NO.	DATE	DESCRIPTION	BY	APP.
1	10/28/20	PCO#2 POLE RELOCATION	KS/MA	MV

19TH AVENUE (STATE ROUTE 1)
COMBINED CITY PROJECT

19TH AVENUE AND RIVERA STREET

CONTRACT NO. 1000005832
DRAWING NO. E-11.0
FILE NO. 111,407
REV. NO. 1

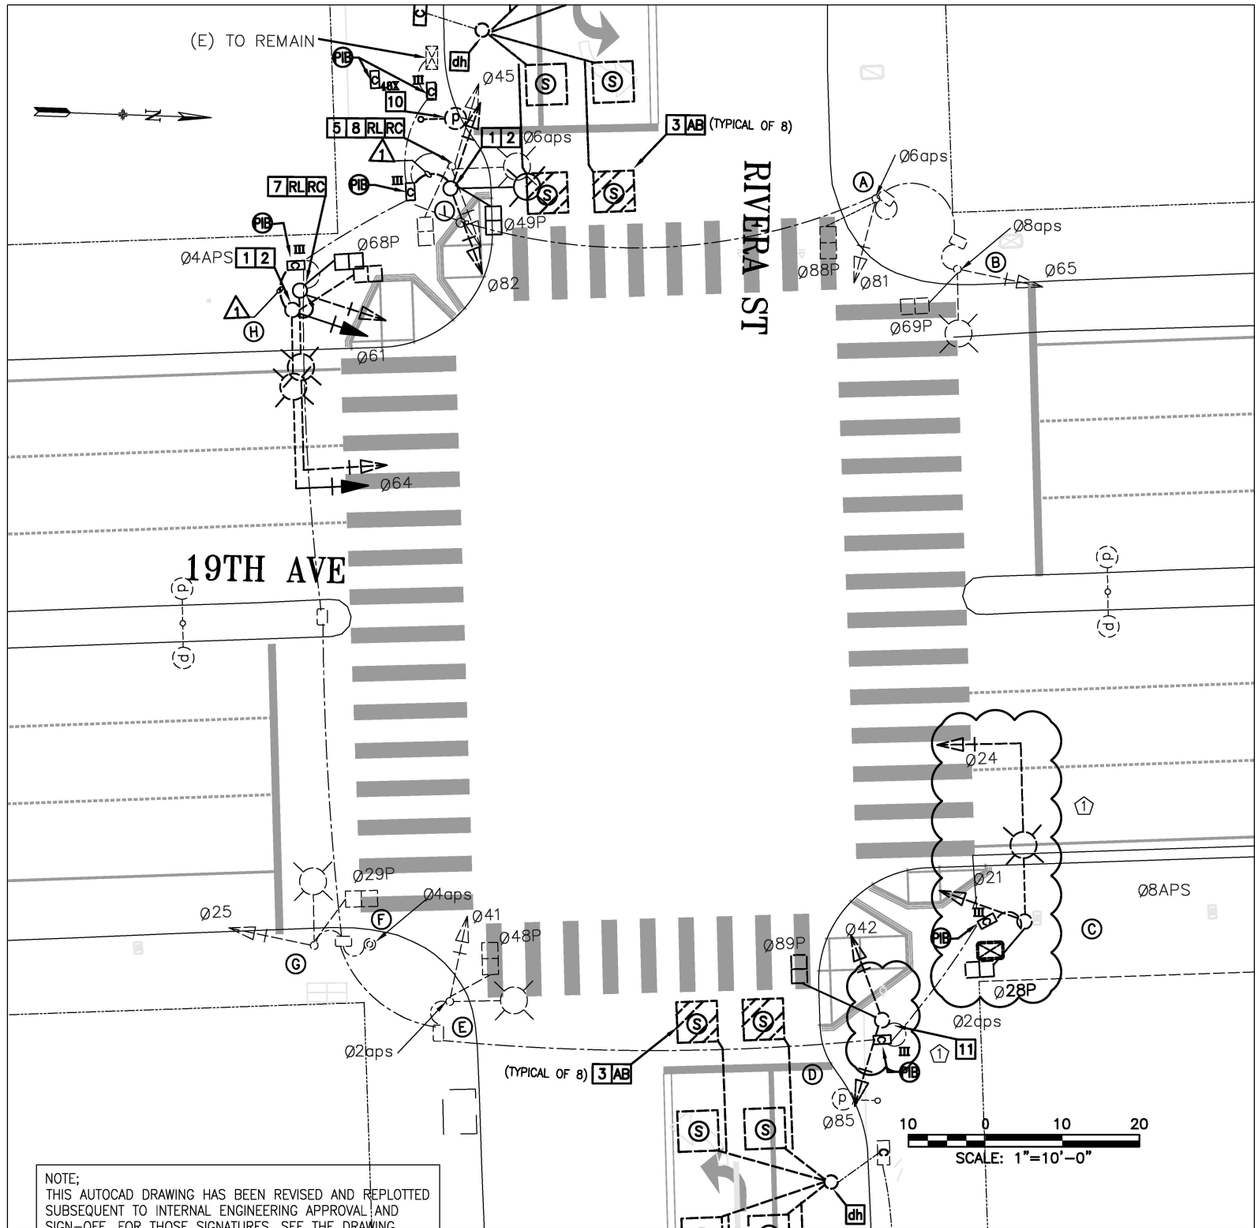
3. CONTRACTOR TO AB LOOP DETECTORS. CITY FORCES TO INSTALL WIRELESS SENSYS DETECTORS IN PLACE OF LOOP DETECTORS.
4. NOT USED. (1)
5. REMOVE AND RC EXISTING POLE, FIXTURE, AND FOUNDATION, AND ASSOCIATED CONDUIT. RL EXISTING SIGNALS AND MOUNTINGS TO POLE I.

6. NOT USED. (1)
7. REUSE AND RL EXISTING MAST ARM POLE AS INDICATED BY POLE H ON NEW FOUNDATION. RL EXISTING STREET LIGHT FIXTURE. RC EXISTING TRAFFIC SIGNAL EQUIPMENT, MOUNTINGS, ASSOCIATED CONDUIT, AND FOUNDATION. PROVIDE NEW TRAFFIC SIGNALS AND MOUNTINGS PER POLE AND EQUIPMENT SCHEDULE. PROVIDE TEMPORARY SIGNAL AND LIGHTING AS REQUIRED.

10. COORDINATE WITH SFPUC FOR REMOVAL OF PG&E STREET LIGHT POLE.
11. CONTRACTOR TO ADJUST POLE ELEVATION SUCH THAT 1.5" TO 4" IS PROVIDED BETWEEN FINISHED GRADE AND BOTTOM OF BASE PLATE – .25" THREAD TO REMAIN ABOVE THE BOLT. (1)
